# 36-50 E. Third Avenue

## Secretary of the Interior's Standards Analysis

City of San Mateo

Architectural Resources Group, Inc.  
San Francisco, California

*Proposed south elevation (taken from Brereton Architects, “Draper University, 44 E 3rd Avenue, Planning Pre-application Revisions,” June 1, 2019). The western wall of the proposed addition should be shifted eastward so as not to partially obscure the building’s sixth bay.*

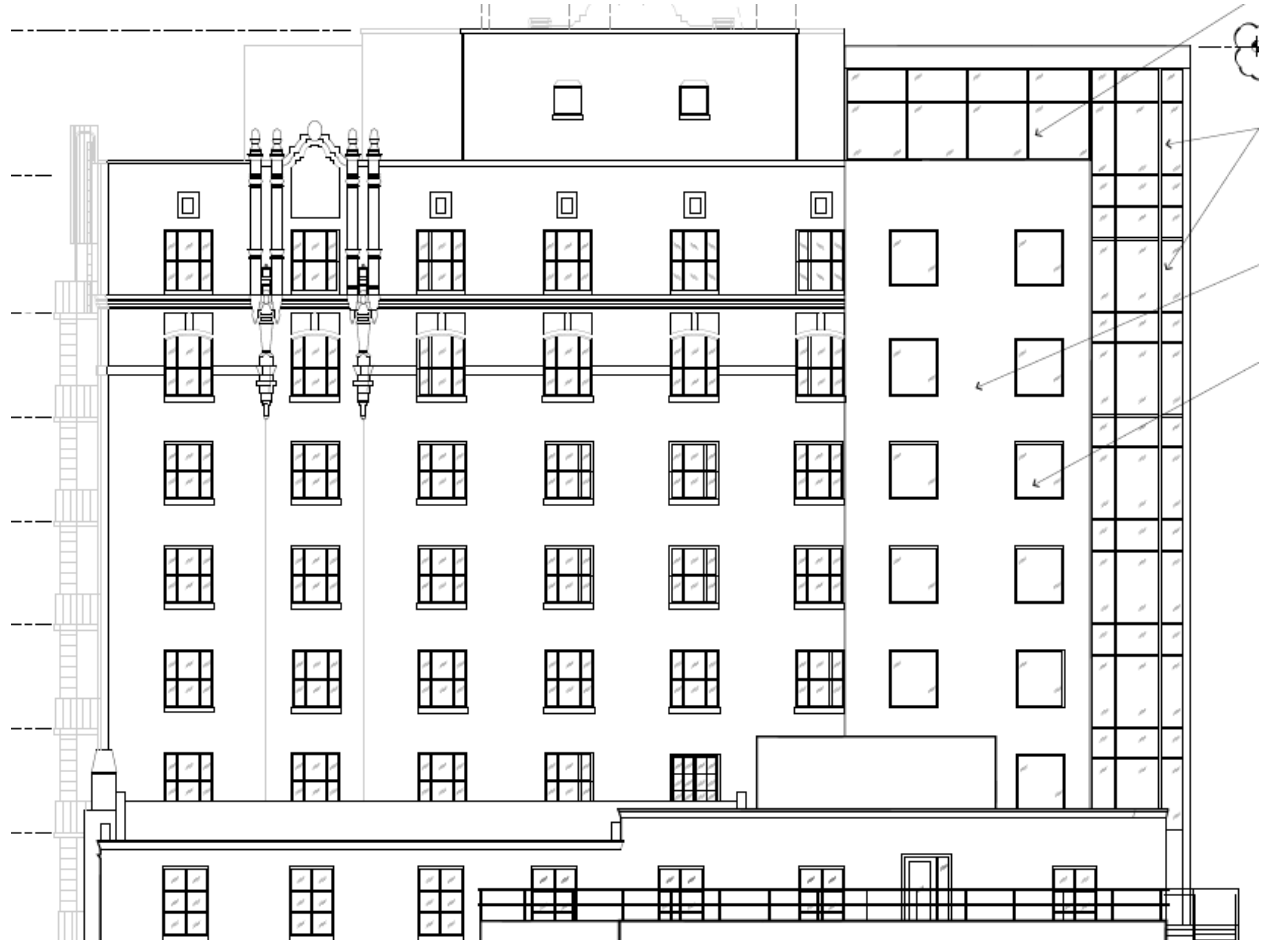
The stairwell and elevator addition’s location at the rear corner of the building reduces its prominence and helps to minimize its impact on the existing building. In addition, the south wall at the stairwell, which consists of punched windows the same size as this façade’s historic windows surrounded by unadorned stucco cladding, is compatible with the building’s Spanish Colonial Revival Style while, through its comparative simplicity, clearly being a contemporary addition.

That said, the proposed design could be modified to better conform to this Standard:

- The architectural plans and renderings show the western wall of the addition meeting the existing building at the eastern edge of the windows in the sixth bay. The addition’s western wall should be shifted eastward so as not to infringe in the windows at the sixth bay. Ideally, this western wall would be shifted to align with the midpoint between the existing windows at the sixth and seventh bays, so as not to obscure any portion of the sixth bay.

- The two bays of punched windows at the stairwell should be shifted to be aligned with the original window openings they are obscuring. In particular, based on the project drawings, it appears that the left bay of new windows should be shifted rightward, and the right bay of windows should be shifted leftward. This change will reduce the extent to which the addition modifies the symmetric character of the rear façade.

- The full height glazing at the elevator shaft and penthouse level of the stairwell is starkly at odds with the building's Spanish Colonial Revival Style. Instead, we recommend that the design approach at the stairwell (stucco cladding with punched windows) be extended to the entire addition. This will enable the addition to be compatible with the historic building, while at the same time, through slightly simpler window, wall and roofline treatments, be differentiated from it.

- The compatibility of the addition could be further reinforced through:
  - addition of a string course between the seventh and eighth stories that is similar to but simpler than that on the existing building; and

- Arched window openings at the south wall of the seventh story that match the existing window openings at that location.
